ADDENDUM No. 1

**Airfield Lighting Vault Expansion
AIP # 3-33-0011-TBD-2025
Bid # FY25-804-38**

at the Manchester – Boston Regional Airport

Date: March 10, 2025

DRAWING NO.
C-200

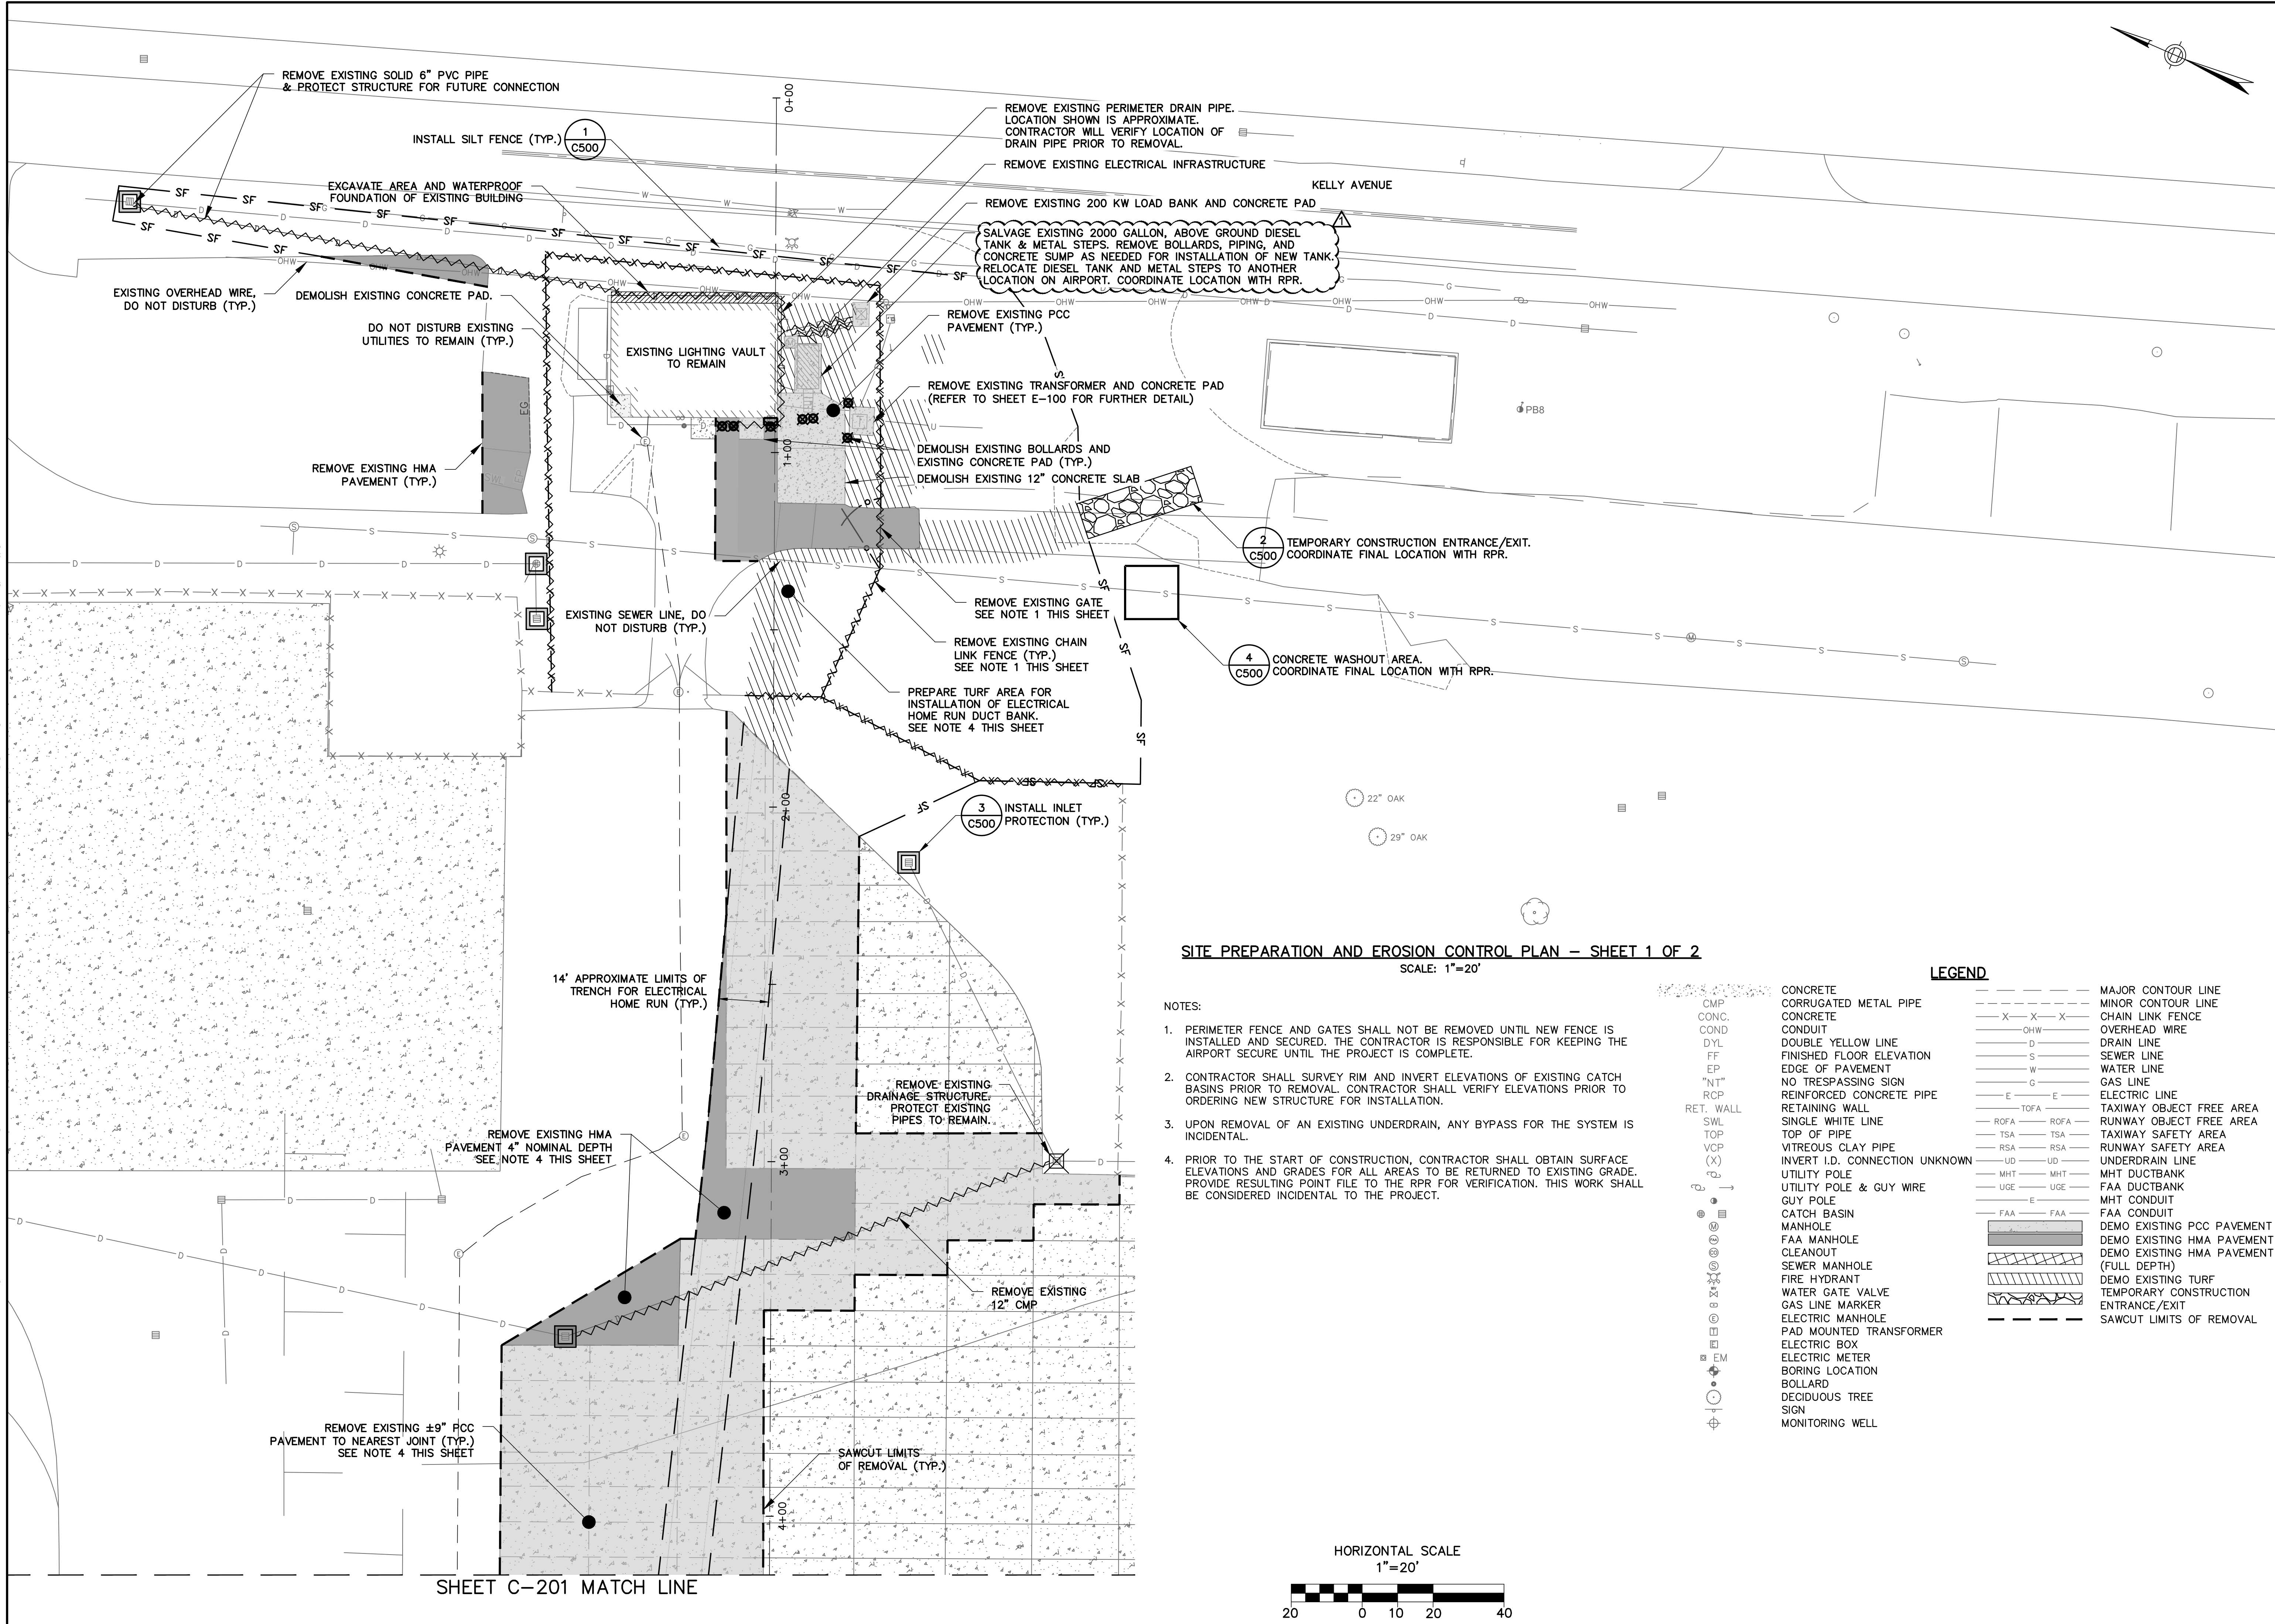
REMOVE Drawing C-200 and REPLACE with Drawing C-200 attached.
